Date: September 5th, 2022

To: Dan Osoba, Planner II
City of Aurora Planning Department

This document is a response to the Harmony SP5 second submission review comments we received on July 14, 2022.

Application Number: DA-1925-11

SHEET 8 OF 11

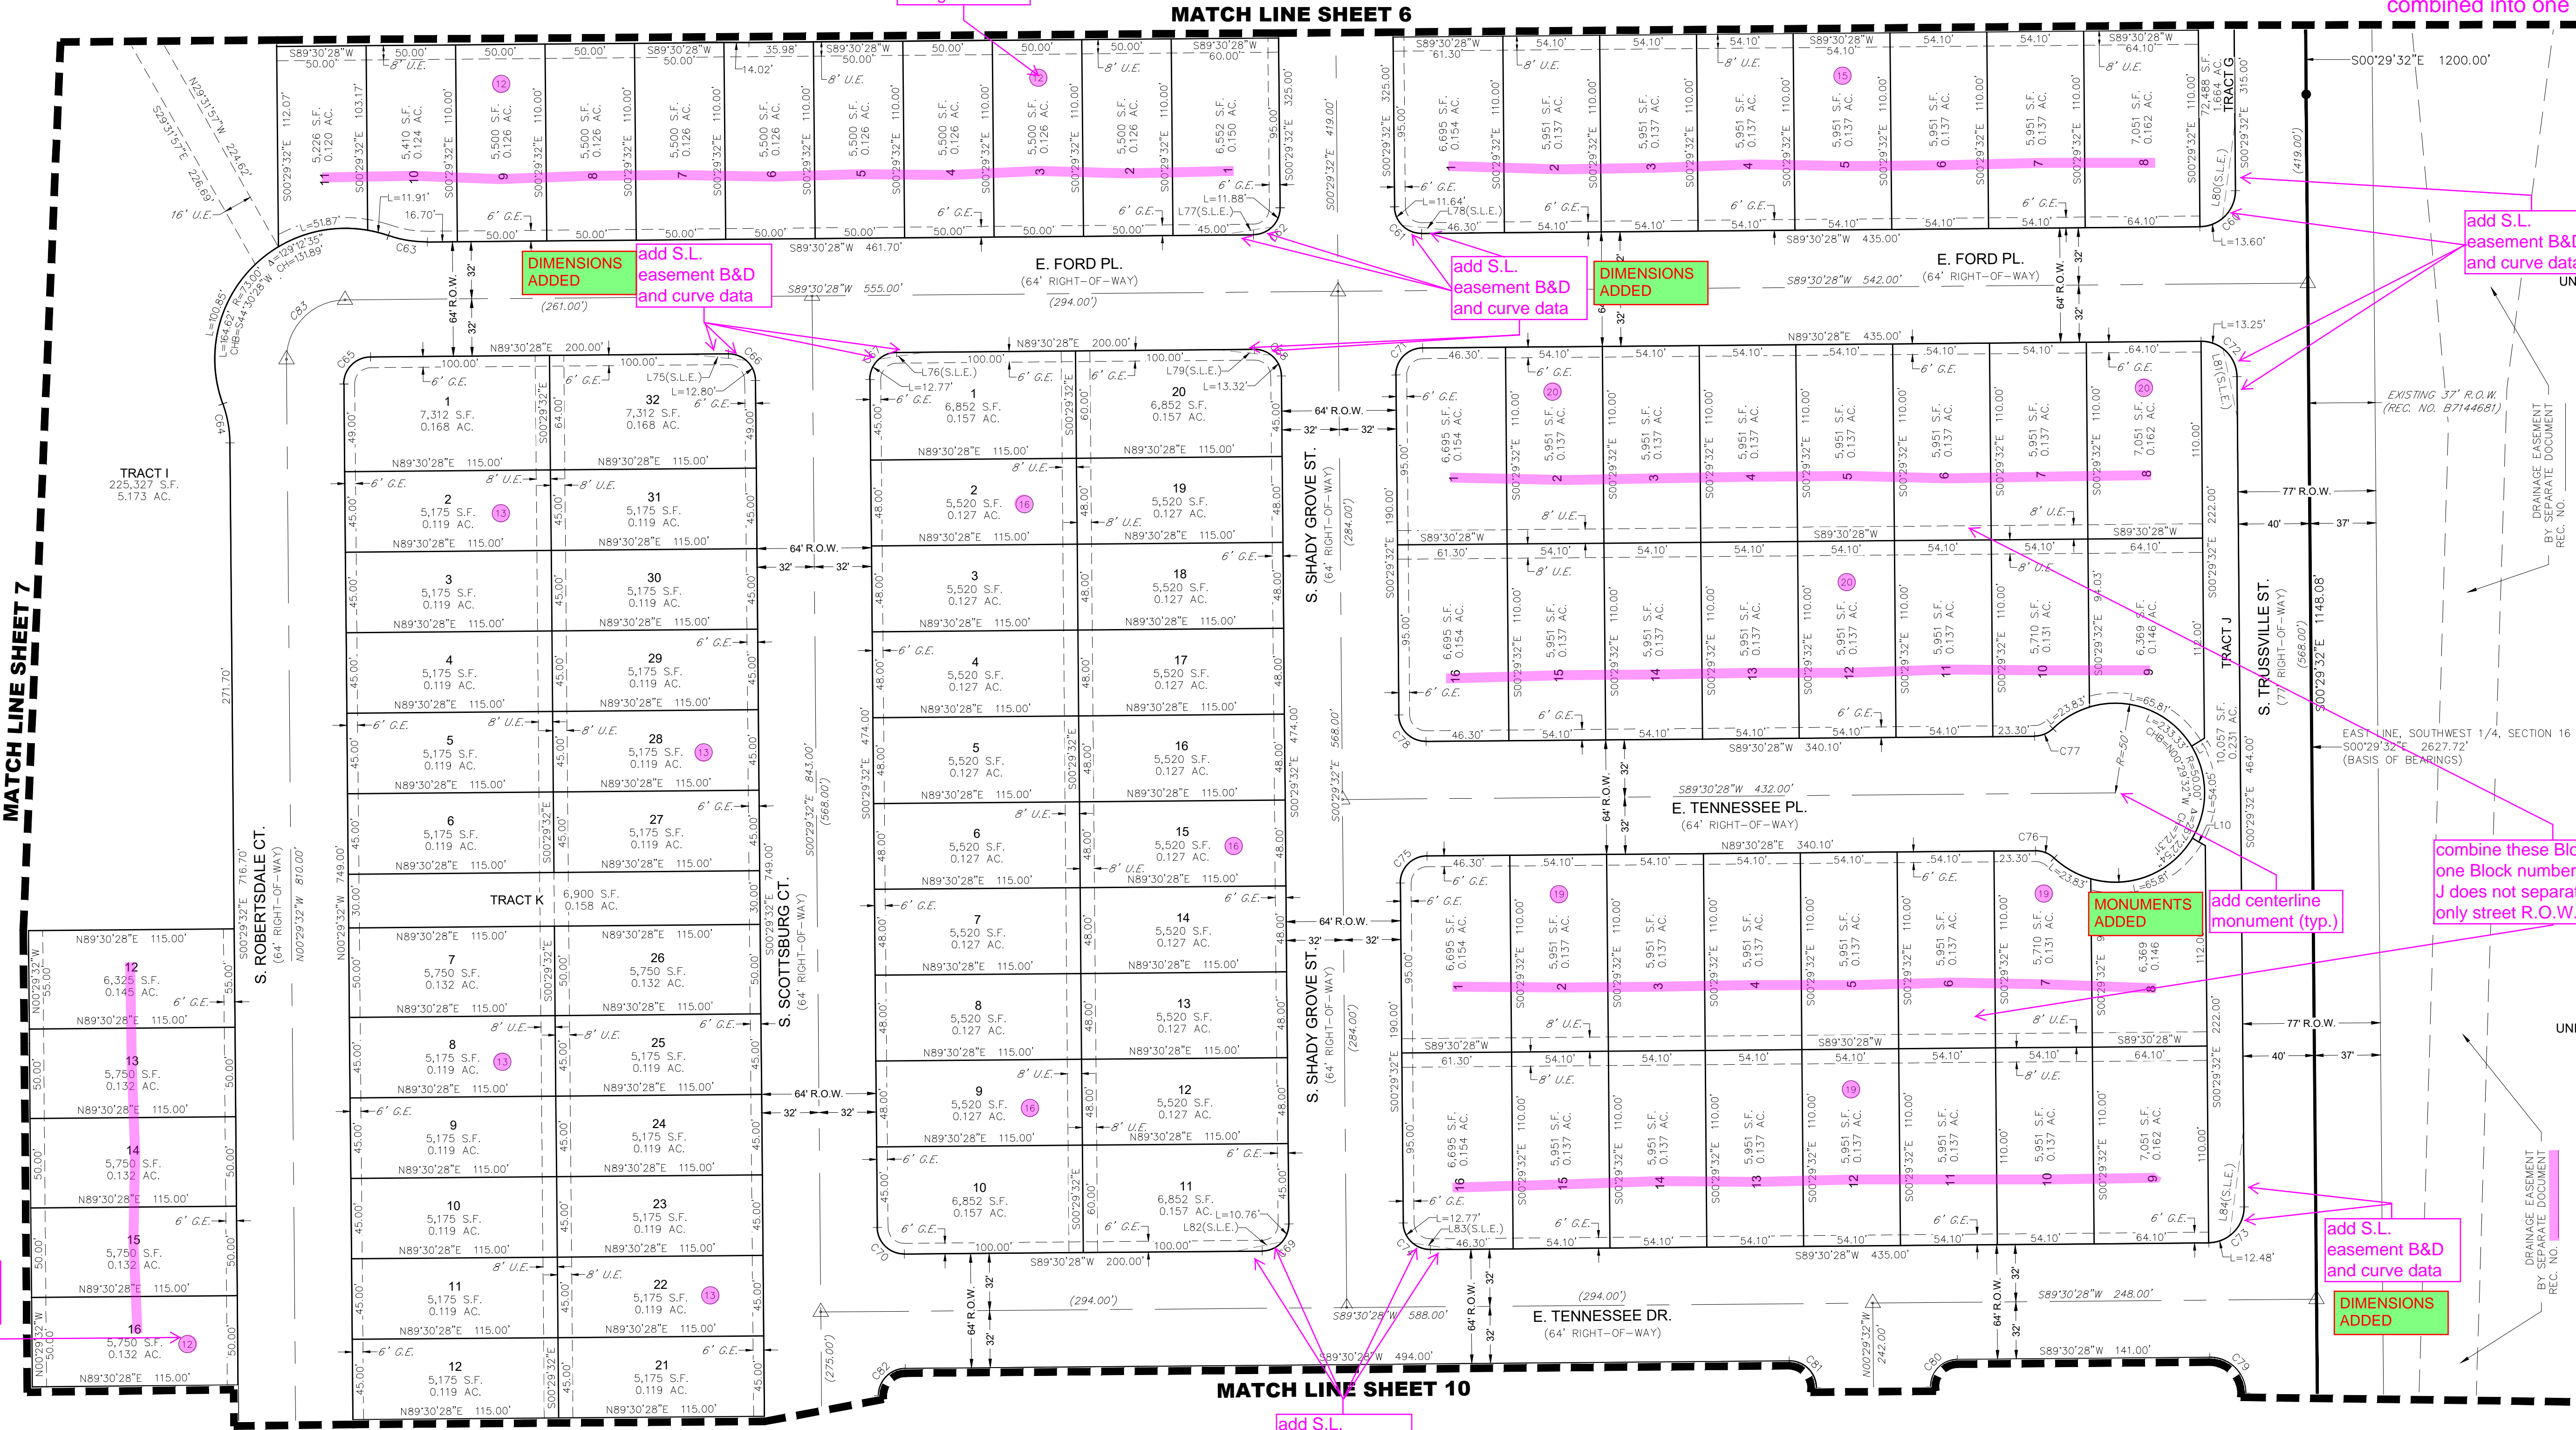
Blocks 12 & 21 need to be combined into one Block

This Block number may be changed

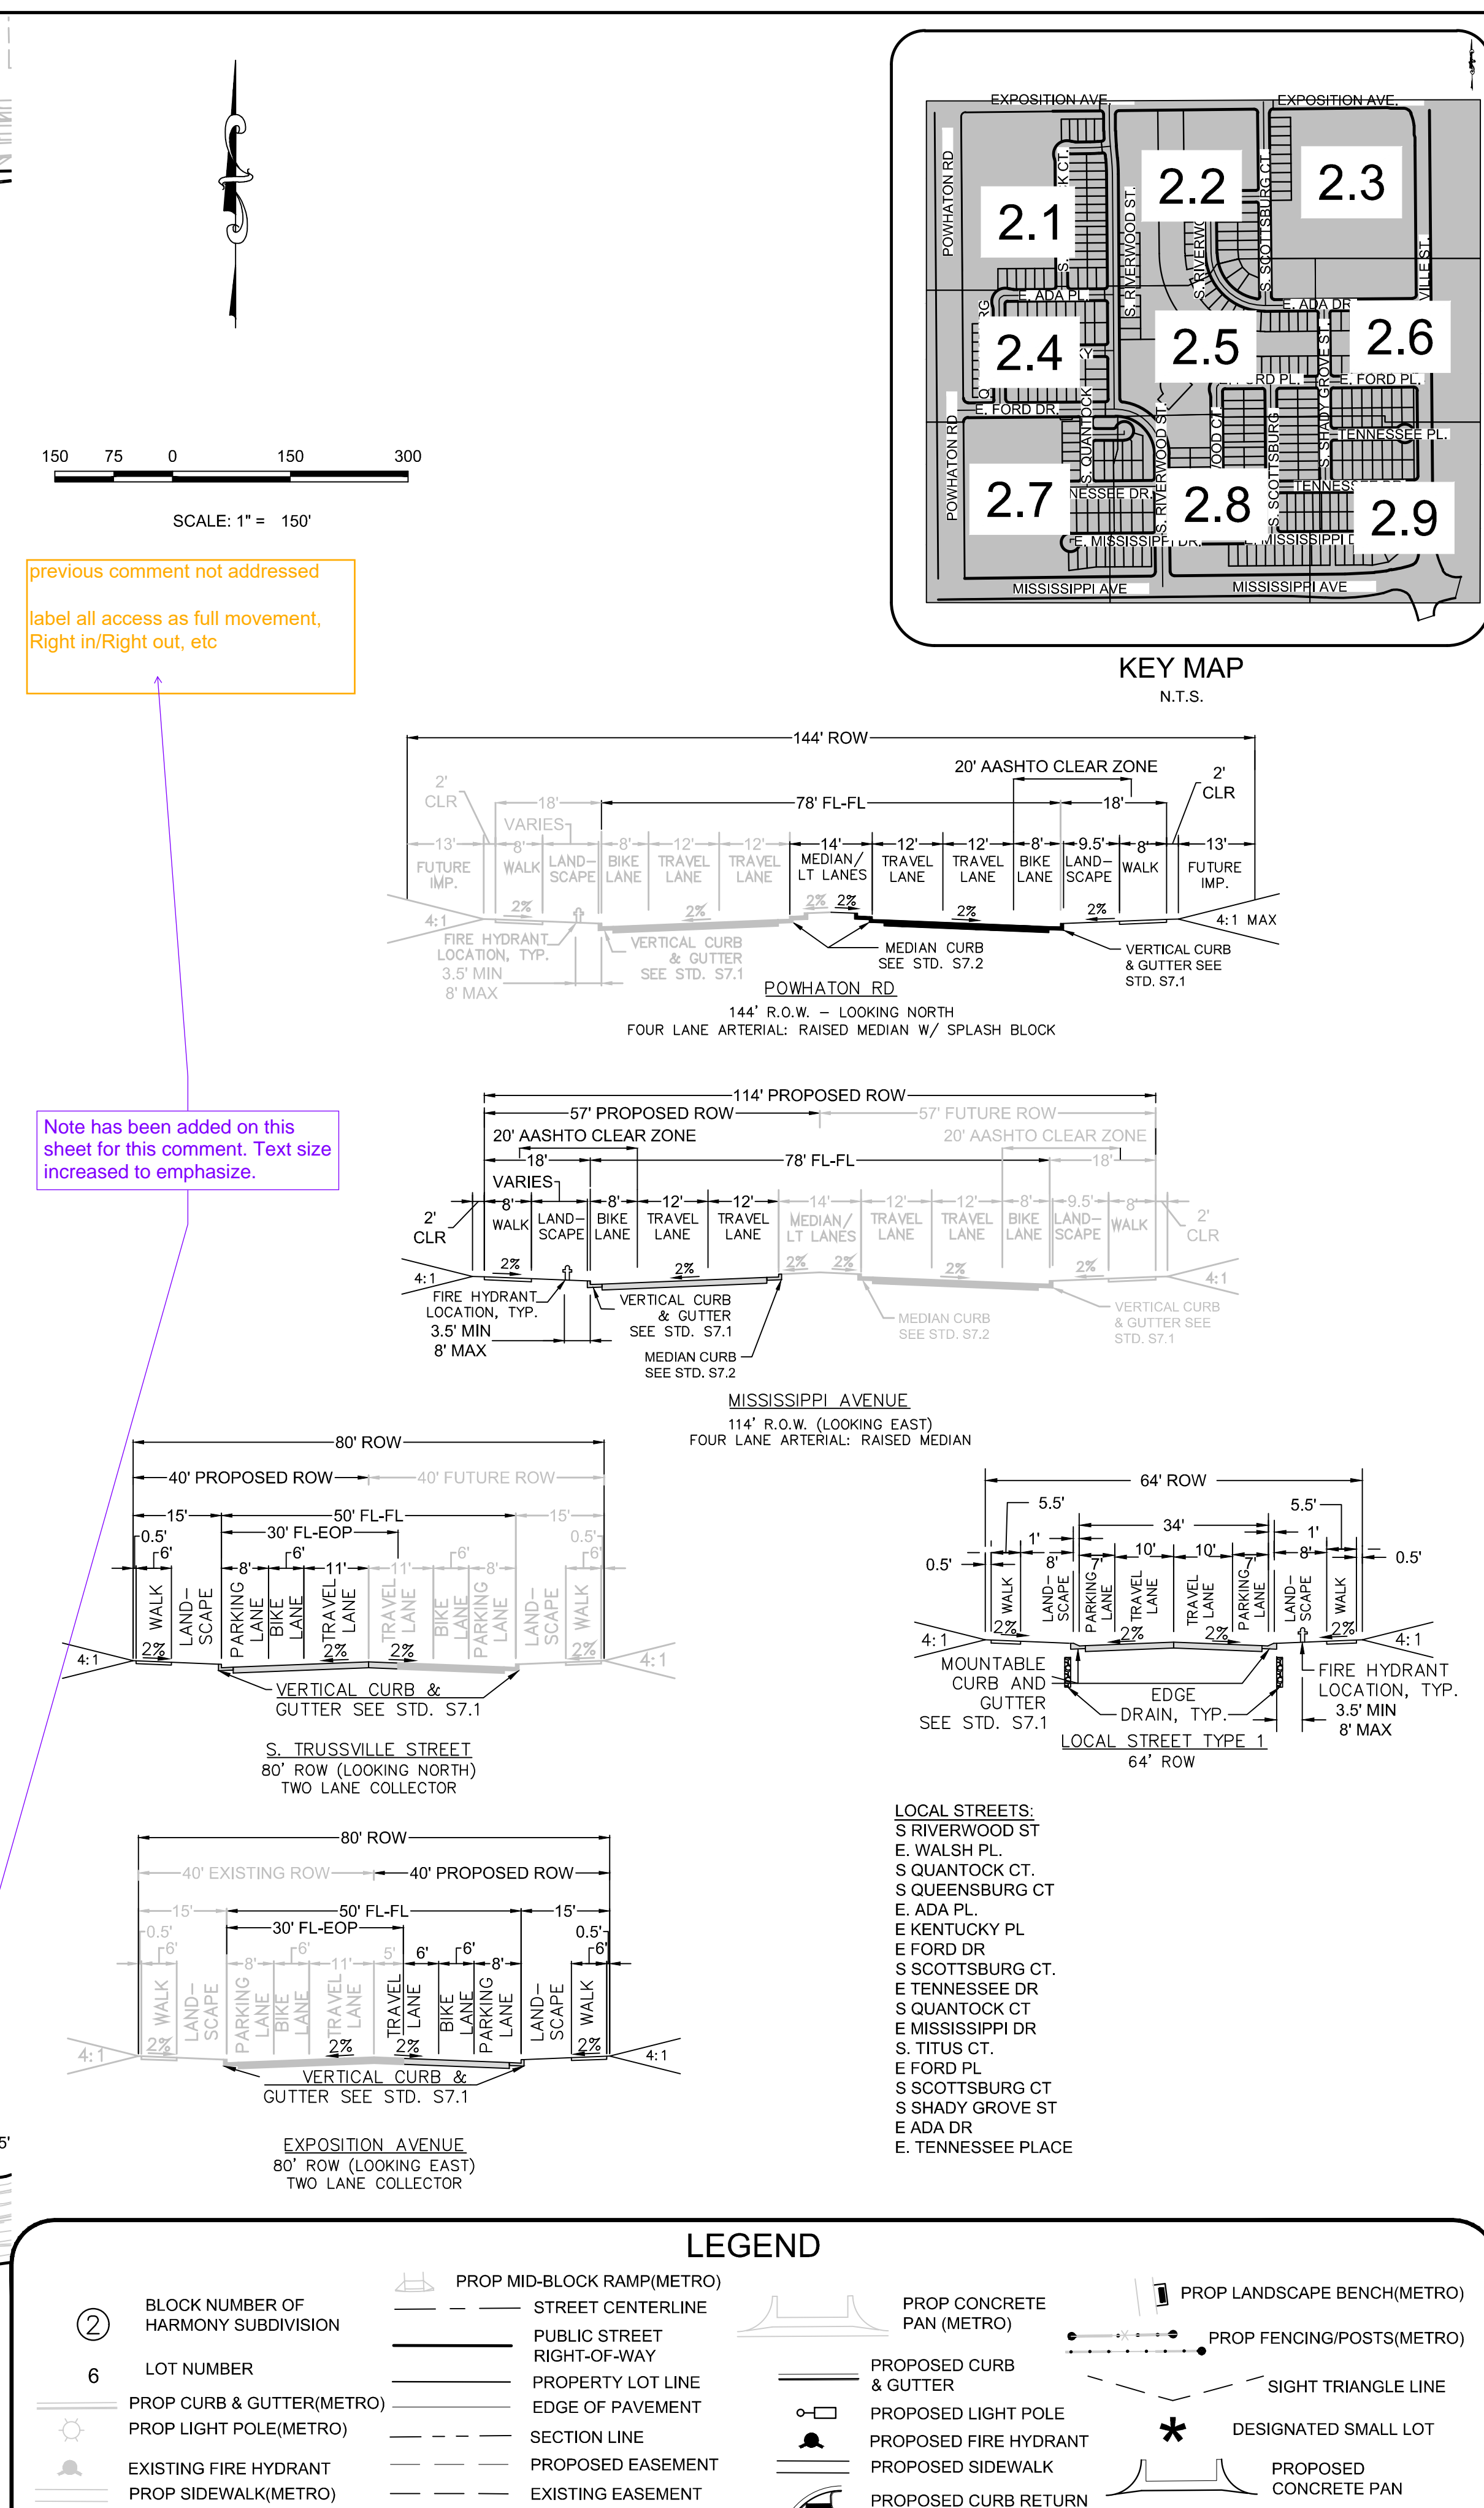
7H. Previous comment not addressed: label all accesses as full movement, right-in/right-out, etc.

WPS Response: A note was added to the sheet to address all movement classifications of each intersection.

Westwood		No.		Revisions		Date		Date	
Melcor/TC Aurora, LLC		C/O Marathon Land Company		9750 W. Cambridge Place Littleton, CO 80127		Tel: (303) 920-9400 Fax: (303) 920-9440			
SCALE: AS SHOWN		DRAWN BY: DJG		CHECKED BY: BPW		FILE NO: 8130214922		DATE: MAY 2022	
SHEET NUMBER		2.8

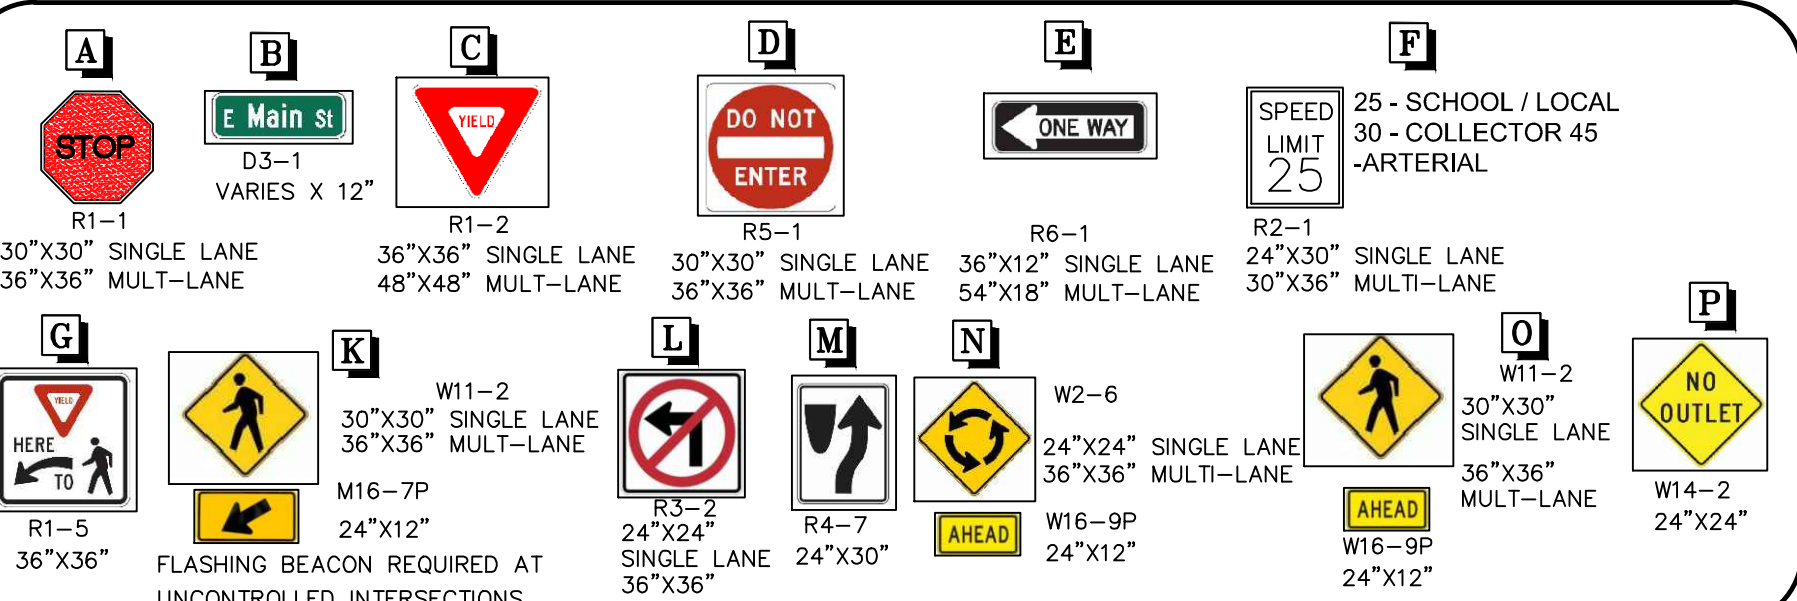
For reference, at a stop sign, a mail kiosk should be placed 30' in advance of the stop sign, but no more than 50' away from that intersection's curb ramp and still be an eligible location. The suggested location Steve noted in his comments do appear to meet criteria. Can you see who made the green comment? I can coordinate with that reviewer, if necessary. The comment on your snip appears at a different kiosk location where the 50' max distance would have been more difficult to meet, so either relocation or addition of curb ramps was going to be needed there.

- For future reference, the criteria we look at placing mail kiosks:
- 1) Outside of AASHTO sight triangles
 - 2) Curb ramps within 50'
 - 3) 30' upstream of any stop sign (for visibility of the stop sign)
 - 4) Preferred to keep away from home frontage/private driveways for their visibility
 - 5) Outside of intersections (to avoid conflicting kiosk movements with the intersection turning movements, etc)

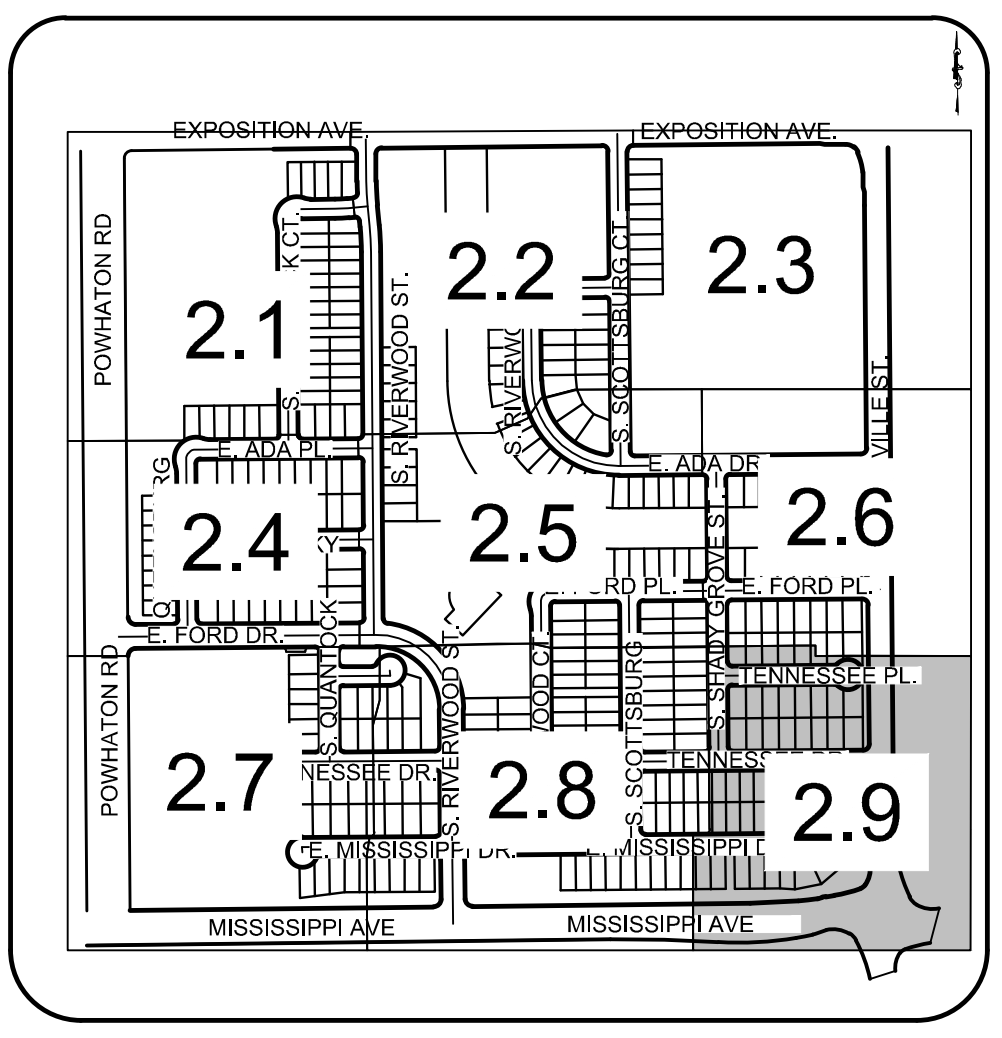
add the B&D and
Curve data for the
boundary of the
platted area (typ.)

Move this mail
kiosk to sheet 2.8
locations.

Figure 9
 Year 2024 Assignment of
 School Site-Generated Traffic
 Harmony Phase 5 (LSC #210910)

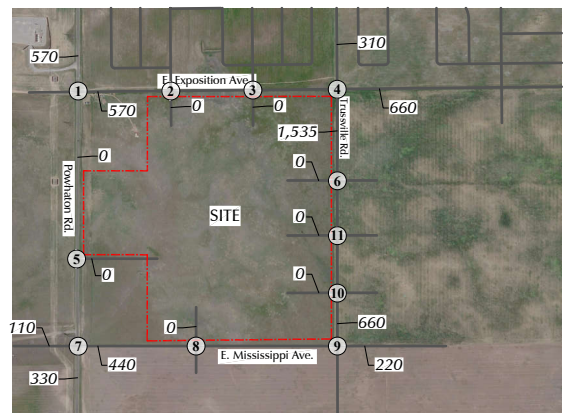
Number: 1 Author: segomez Subject: Text Box Date: 7/5/2022 1:12:48 PM
add 2024 total site traffic graphic

Author: kdferrin Subject: Sticky Note Date: 8/17/2022 8:50:37 AM
LSC Response: The additional graphic has been added as requested
